Submissions Report

GRIFFITH SOLAR FARM

MAY 2016

Project Title:	Griffith Solar Farm Submissions Report
----------------	--

Figure 4 Consideration of Submissions-3 Avian deaths per year in the United States from various energy and non-energy sources, 2009.

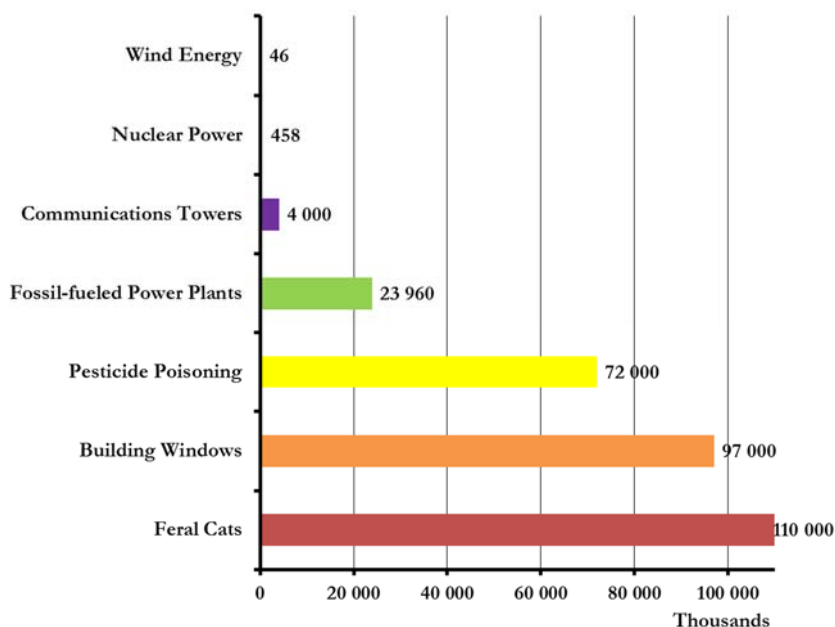
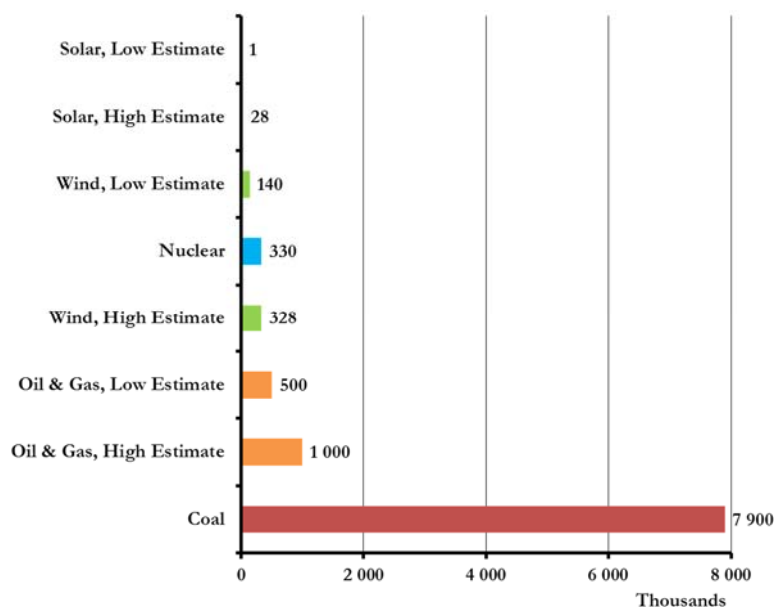
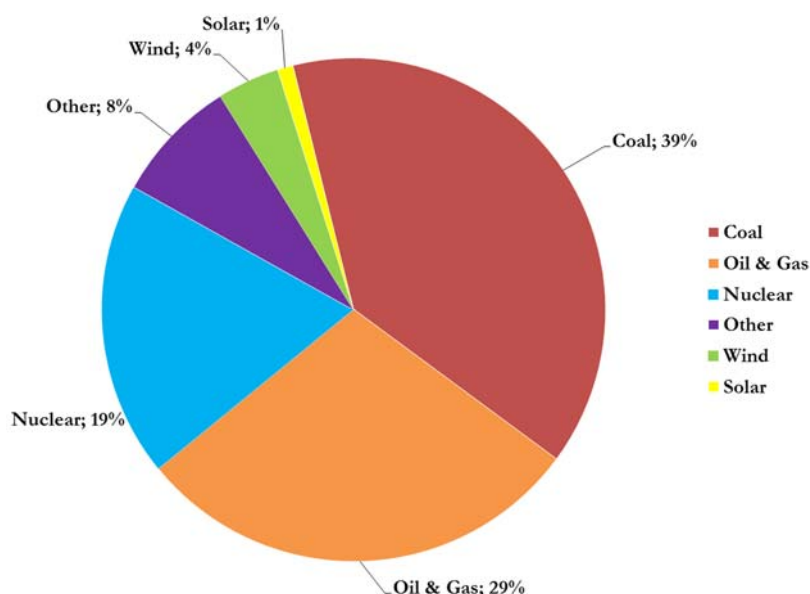
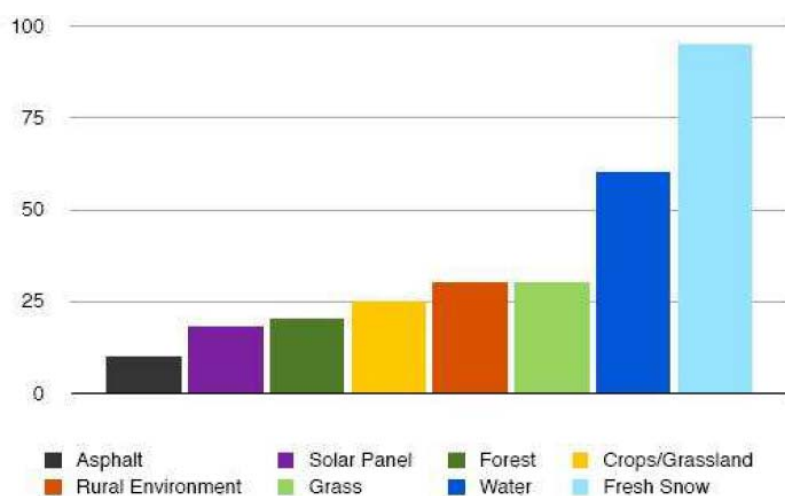
Neoen contacted the Murrumbidgee Naturalist Group directly, as the most relevant local special interest group, to discuss this matter. The group provided a response that while there was potential for this effect, they did not consider the impacts would be substantive due to the proposal. This additional submission is included as Appendix C.

Some of the identified causes of bird deaths include cats, building windows, pesticides, fossil-fueled plants, nuclear power plants, communication towers, nuclear power and wind energy, as shown in the chart in Figure 4.

While Neoen can't confirm that the Griffith Solar Farm will have no impact on birds, it should be highlighted that other causes like houses or pets are responsible for a very significant number of bird fatalities and that solar farms don't count among the identified major causes of bird deaths.

While the first chart is not sufficient to provide information on the relative impact of each energy source, this information can be obtained by combining the 2 charts and identifying what the impact of each technology would be if each of them had the same weight in the electricity generation mix. Table 4 summarises the impact of each source in this case:

However as mentioned above, solar photovoltaic panels are designed to absorb rather than reflect light: typical PV panels are designed to reflect only some 2% of incoming sunlight. The panels will not generally create noticeable reflection compared with an existing roof or building surfaces. The following chart (Figure 7) from 2011 Spaven Consulting report shows that solar panels have a lower reflectivity than most other everyday objects.

Therefore it seems very unlikely that the Griffith Solar Farm will attract more birds to the adjacent food crops than what is already happening today.

No proposal modification or additional mitigation strategies have been included in relation to this matter.
